Access Compliance Report Public Rights-of-Way (Curb Ramps)

Main Street: TUCKER_LN Cross Street: KENSINGTON_RD Location: SE

ADA ID: RPRK211220134521 Ramp Type: Type 1 - Perpendicular Diagonal Initial Pass/Fail: Pass Overall Compliance: No Severity Score: 10

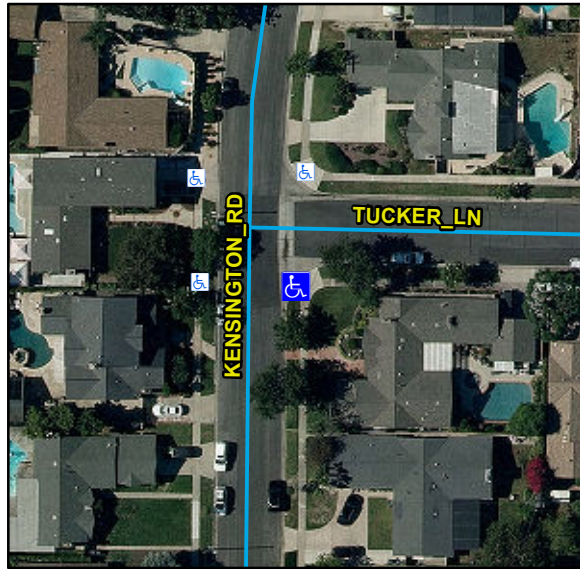
Compliance	Description	Data	Compliance	Description	Data
N/A	Ramp Length (in)	74	N/A	Flare Type LT	
Yes	Ramp Width (in)	48			Sloped
Yes	Ramp Run Slope (%)	8.2	N/A	Flare Slope LT (%)	6.4
Yes	Ramp Cross Slope (%)	0.4	N/A	Flare Traversable LT	No
N/A	Landing Present	Yes	N/A	Flare Type RT	
N/A	Landing Length (in)	49			Sloped
Yes	Landing Width (in)	48	N/A	Flare Slope RT (%)	3.2
No	Landing Run Slope (%)	2.2	N/A	Flare Traversable RT	No
Yes	Landing Cross Slope (%)	0.9	No	DWS Provided	No
N/A	Landing Movement Obstructed?	No	N/A	DWS Contrast	N/A
	Landing Movement Type	N/A	N/A	DWS Length (in)	N/A
N/A	Landing Shared	No	N/A	DWS Full Width	N/A
N/A	Clear Space	Yes	N/A	DWS Offset Left (in)	N/A
N/A	Clear Space To Crosswalk (in)	48	N/A	DWS Offset Right (in)	N/A
N/A	Marked Crosswalk 1	No	N/A	Marked Crosswalk 2	No
	Crossing 1 Direction	N		Crossing 2 Direction	W
	Marked Crosswalk 1 Width (in)	N/A		Marked Crosswalk 2 Width (in)	N/A

N/A	Ramp Inside Crosswalk 1	N/A	Yes	Ramp Inside Crosswalk 2	N/A
	Crossing 1 Slope (%)	5.4		Crossing 2 Slope (%)	5
	Crossing 1 Cross Slope (%)	0.6		Crossing 2 Cross Slope (%)	1
Yes	Gutter Ponding	No	Yes	Curb Slope	1.5
Yes	Gutter Lip Height (in)	0		Road Run Slope (%)	1.2
Yes	Gutter Run Slope (%)	2.7		Road Cross Slope (%)	0.7
Yes	Gutter Cross Slope (%)	1.2			
Yes	Overall Surface Condition: Acceptable		No	Perp Joint Present	No
	Cross Gutter Present?	Yes		Spandrel Present?	Yes
	Replace Cross Gutter?	No		Replace Spandrel?	No

Possible Solutions:

Remove & Replace Curb Ramp With Two New Directional Ramps or Equivalent.
